DECISION NO. RRJ0000-OR-470-7229

for replacement of the bolts providing the reduced tightness in the connection joint of the attachment mounts with the horizontal stabilizer hinge bracket on the RRJ-95 aircraft

**Procedure for
replacement of T7.92.3100.077.000.73 hollow bolts to T7.92.3100.177.000.73 bolts**

Demounting of the hollow bolt (T7.92.3100.077.000.73) along the lower hinge fitting of the stabilizer
Figure 3 (sheet 1 of 3)

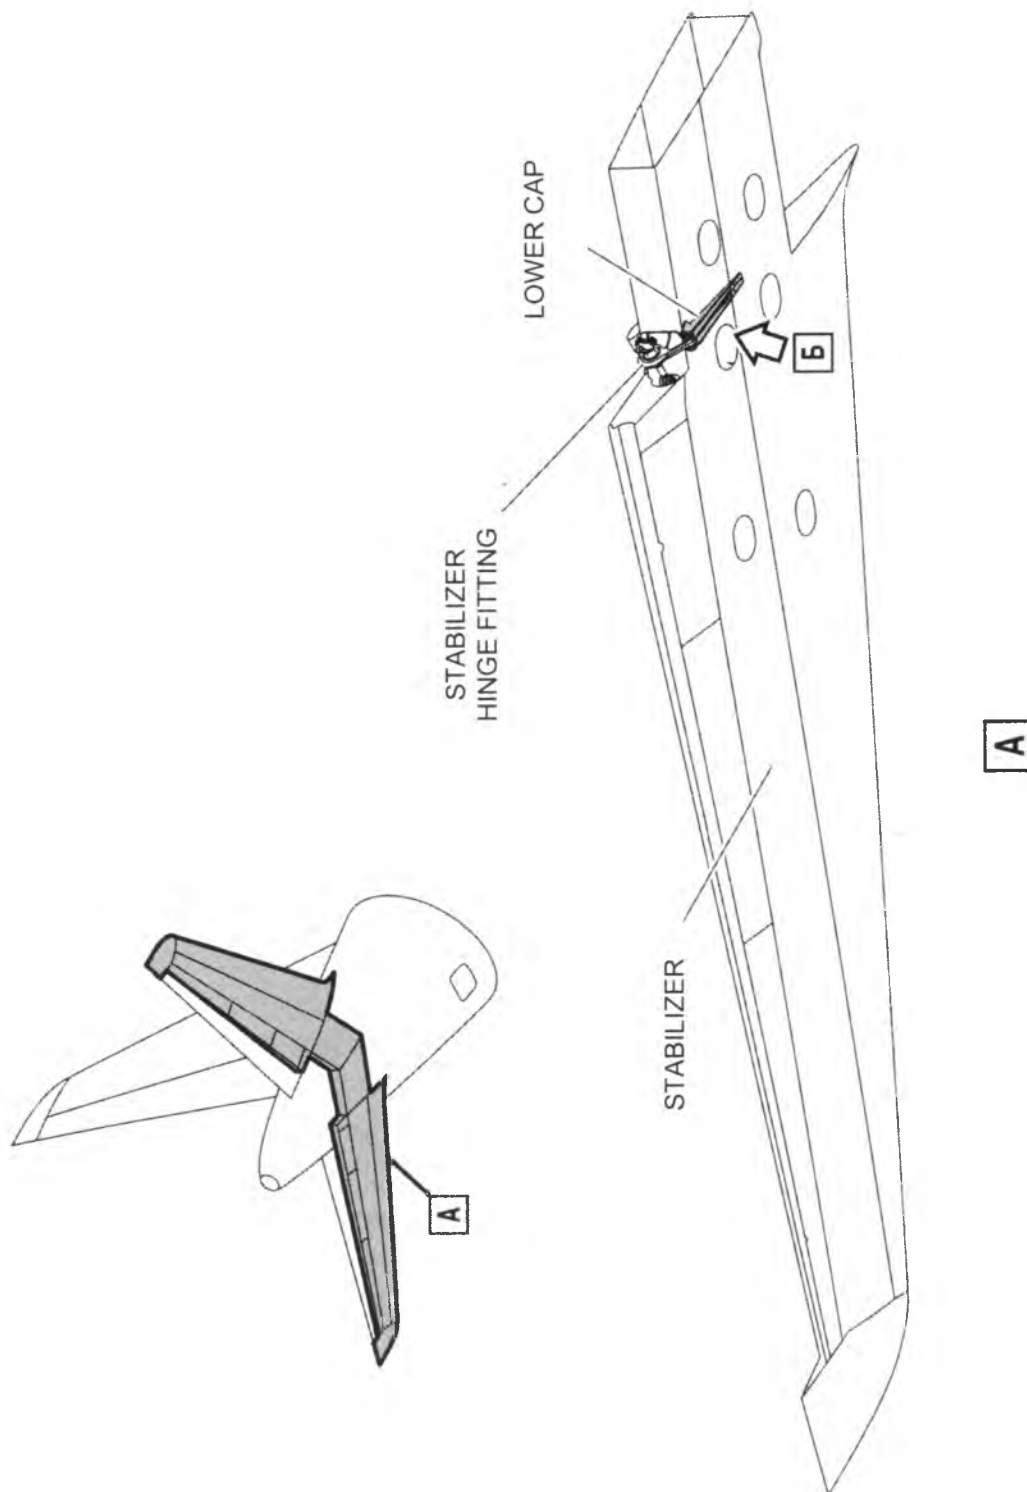
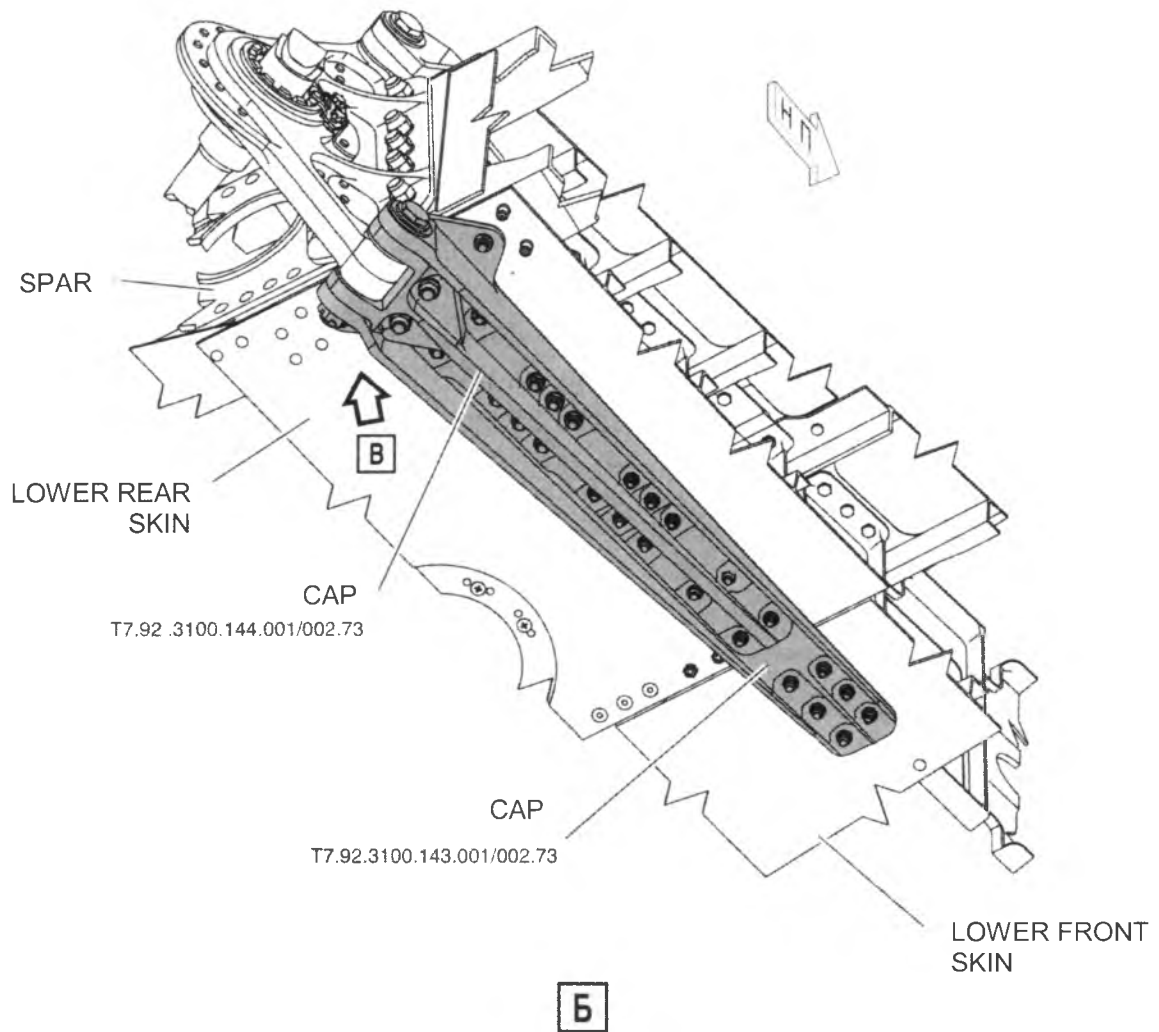
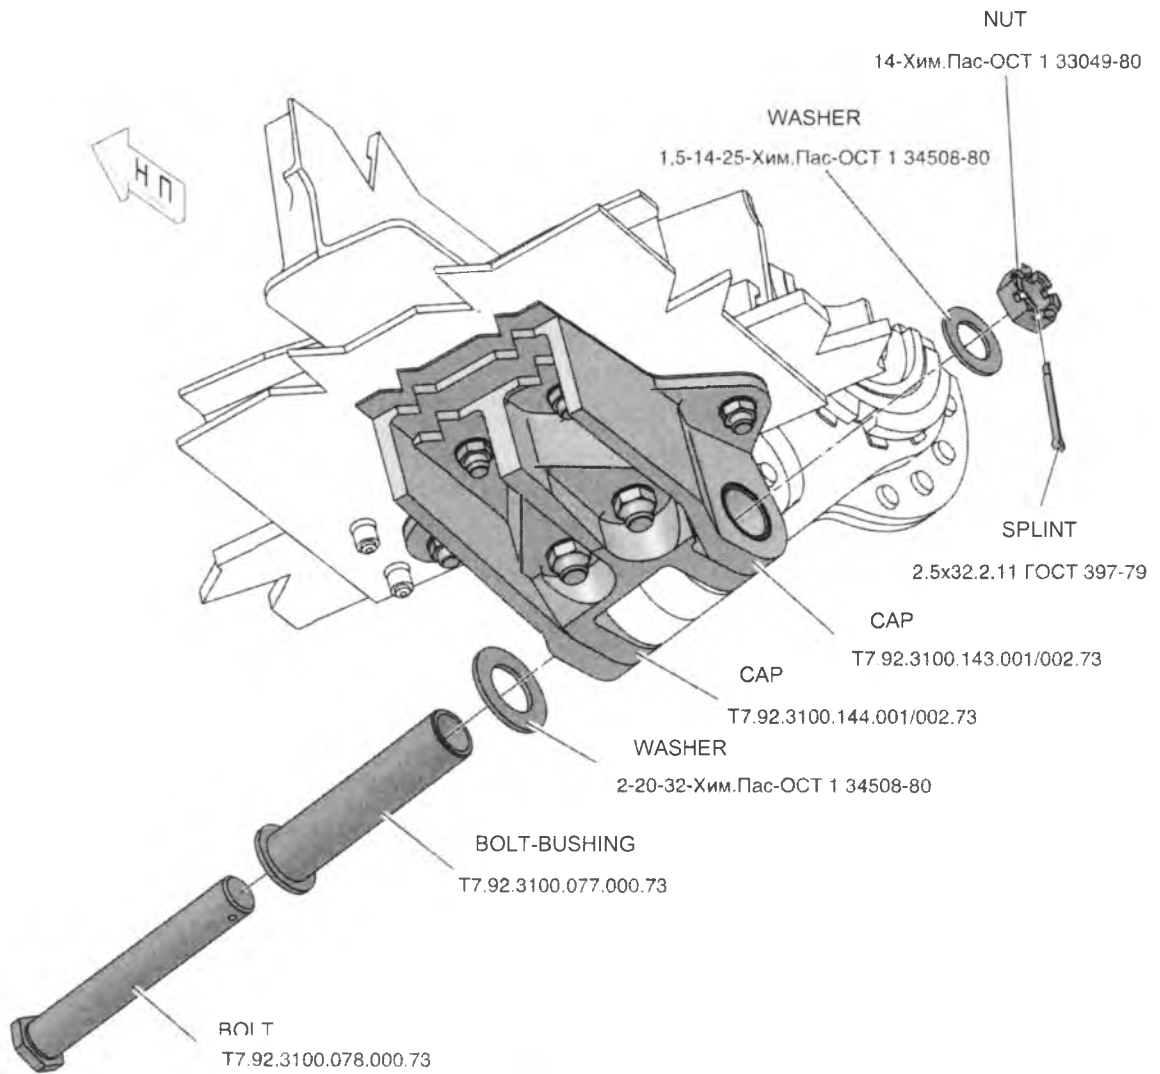
- (3) Demounting the hollow bolt (T7.92.3100.077.000.73) along the lower hinge fitting of the stabilizer (see Fig. 3).
- (a) Clean the surfaces of the upper cap from a dirt with the cleaning rags dampened with НЕФРАС-С2-80/120 solvent if necessary.
 - (б) Remove the 2,5x32.2.11 ГОСТ 397-79 splint and discard.
 - (в) Remove the 14-Хим.Пас-ОСТ 1 33049-80 nut of the lower cap attachment to the fitting of the stabilizer. Save it the nut for the further installation.
 - (г) Remove the 1,5-14-25-Хим.Пас-ОСТ 1 34508-80 washer and save it for the further installation.
 - (д) Remove the bolt (T7.92.3100.078.000.73) and save it for the further installation.
 - (е) Carefully remove the bolt-bushing (T7.92.3100.077.000.73) from the lugs of the lower cap. Discard the bolt-bushing.
 - (ж) Remove the 2-20-32-Хим.Пас-ОСТ 1 34508-80 washer and save it for the further installation.

Installation of the hollow bolt (T7.92.3100.177.000.73) along the lower hinge fitting of the stabilizer
Figure 4 (sheet 1 of 3)

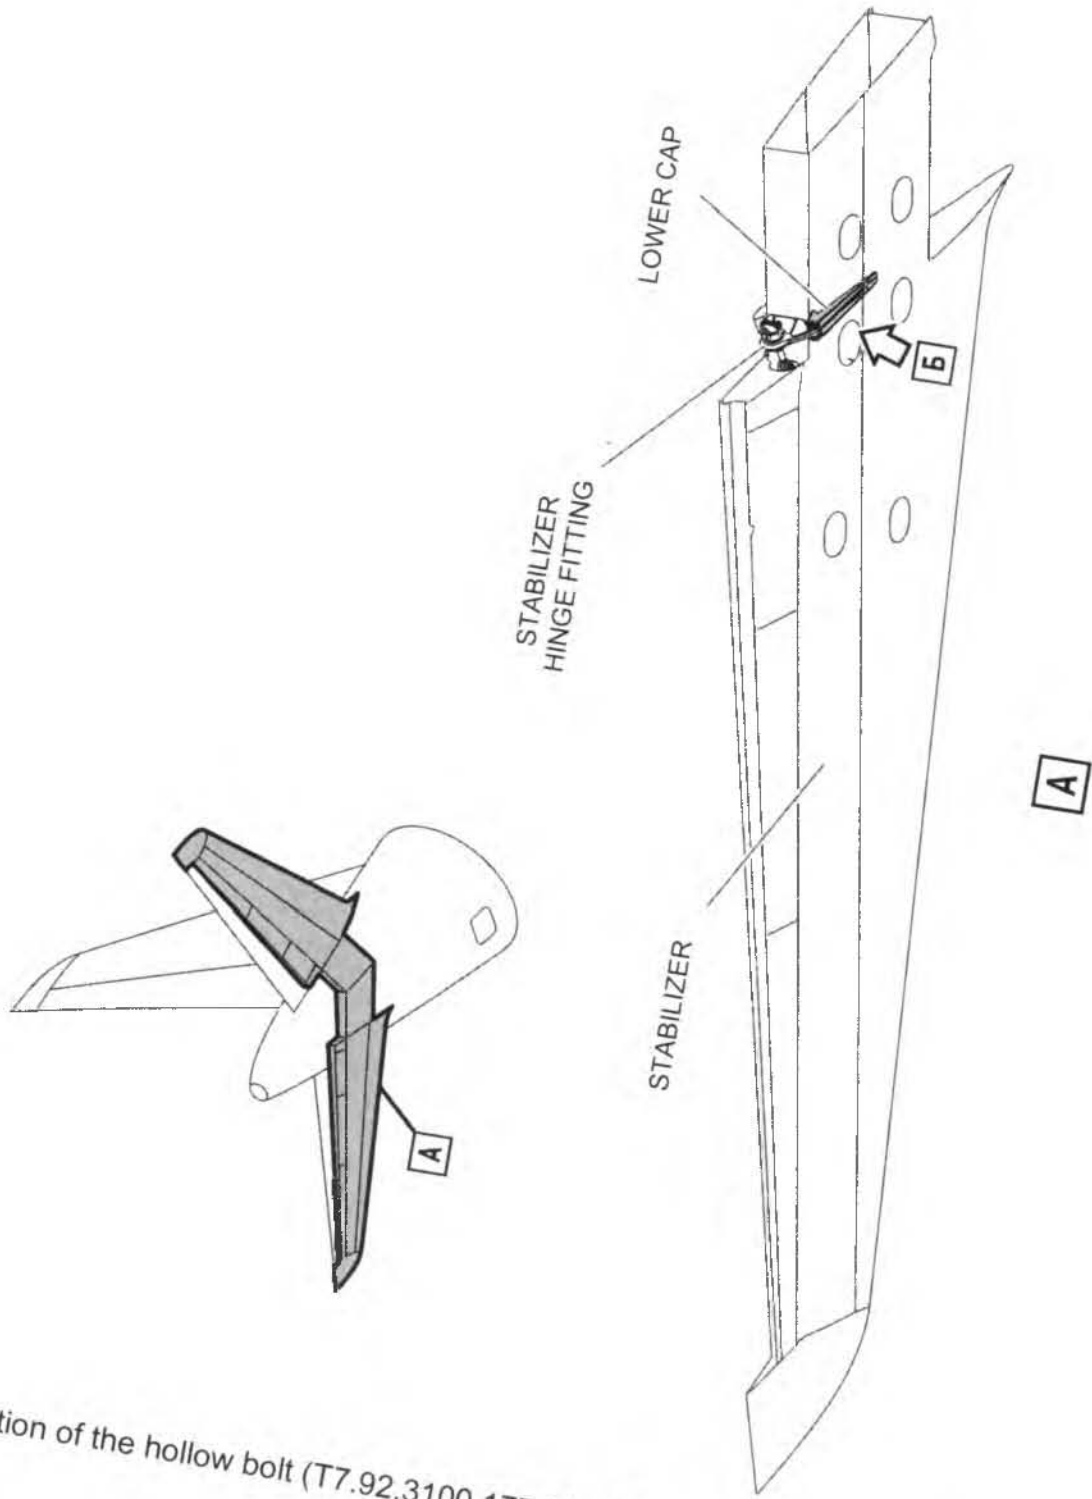
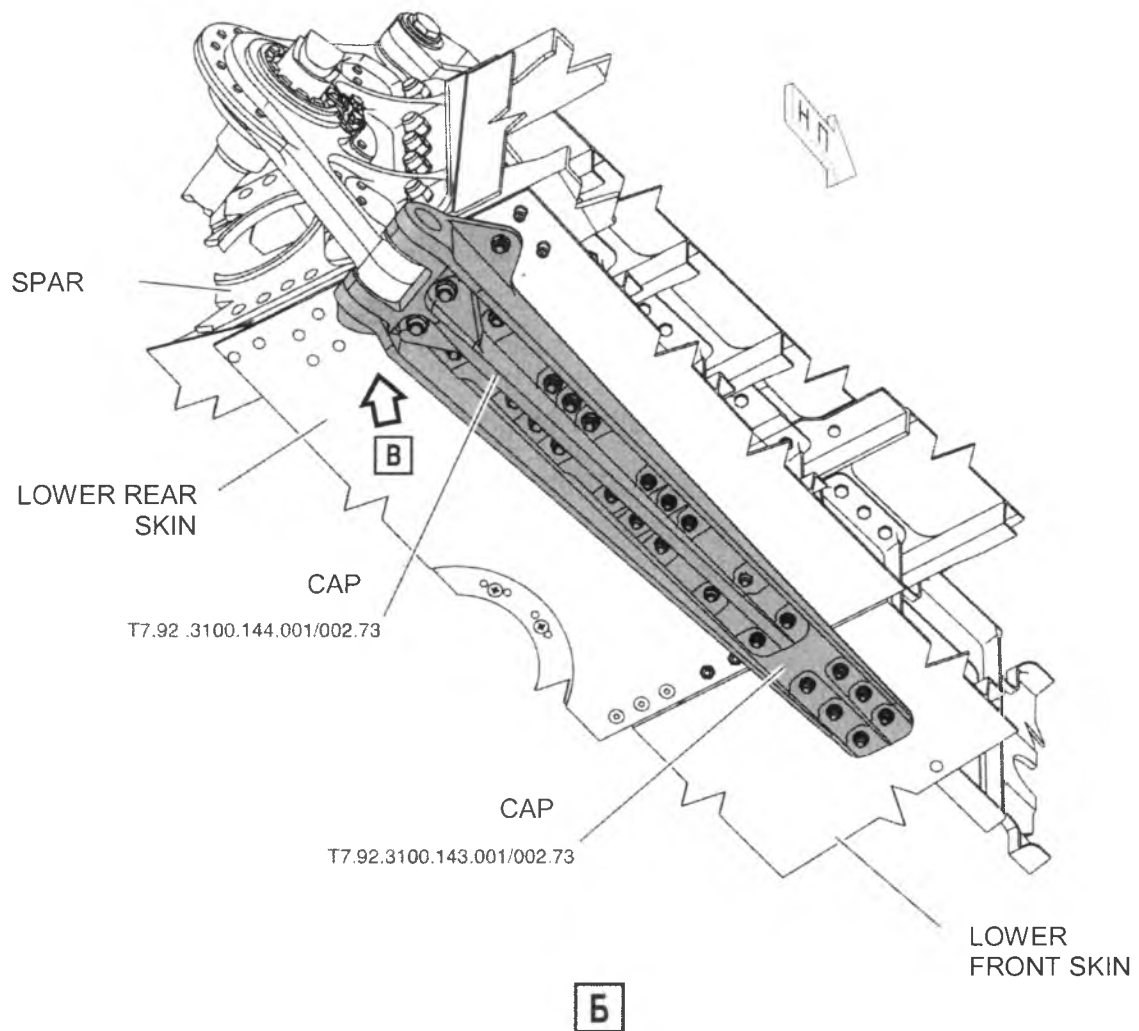
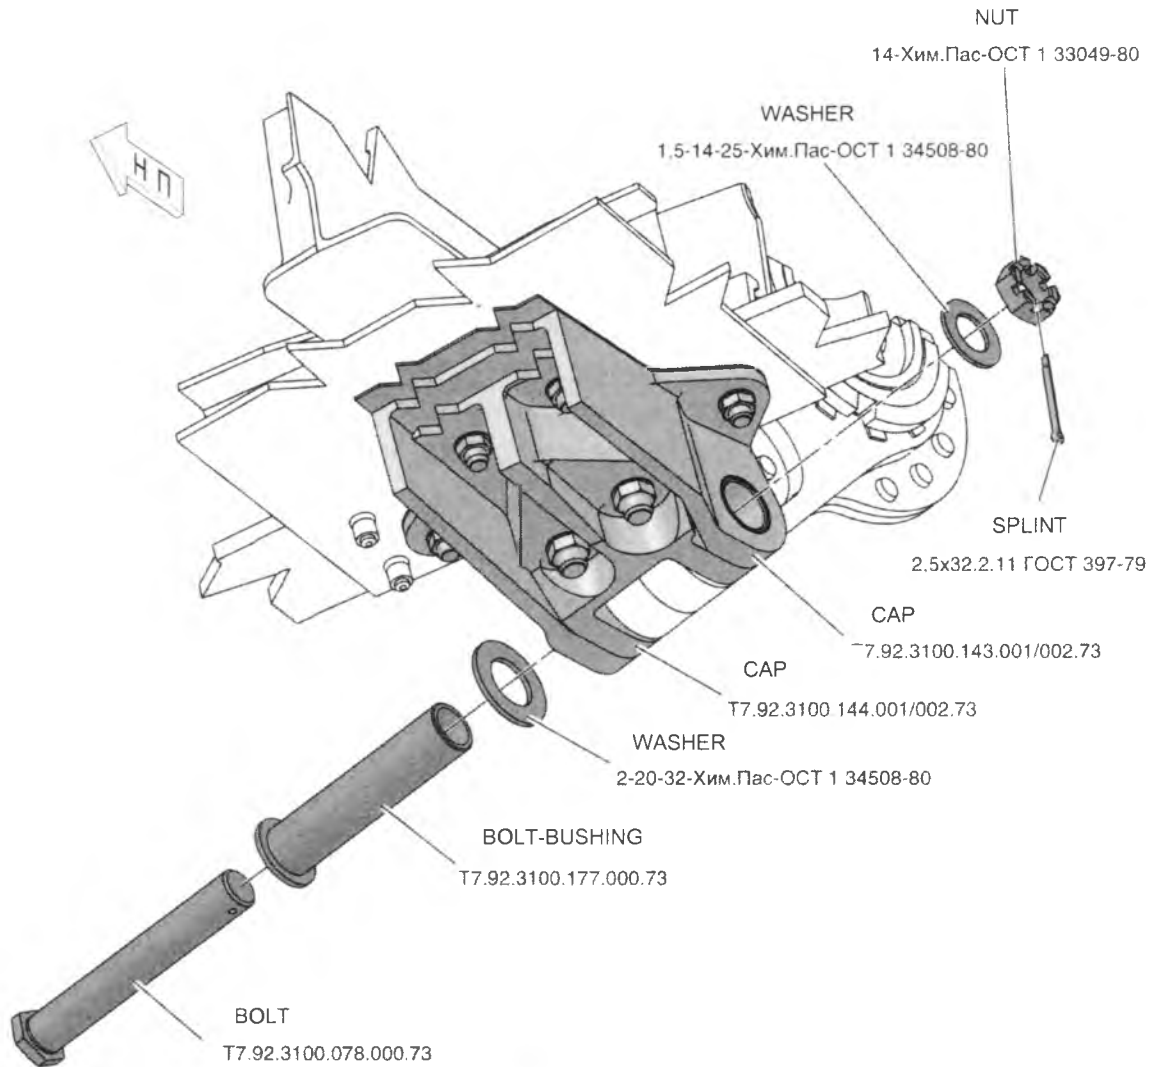
(4) Installation of the hollow bolt (T7.92.3100.177.000.73) along the lower hinge fitting of the stabilizer (See. Fig. 4).

- (a) Install the previously removed 2-20-32-Хим.Пас-ОСТ 1 34508-80 washer and new bushing (T7.92.3100.177.000.73) to the lug of the lower.

- (б) Install the previously removed bolt (T7.92.3100.078.000.73).

- (в) Install the previously removed 1,5-14-25-Хим.Пас-ОСТ 1 34508-80 washer.
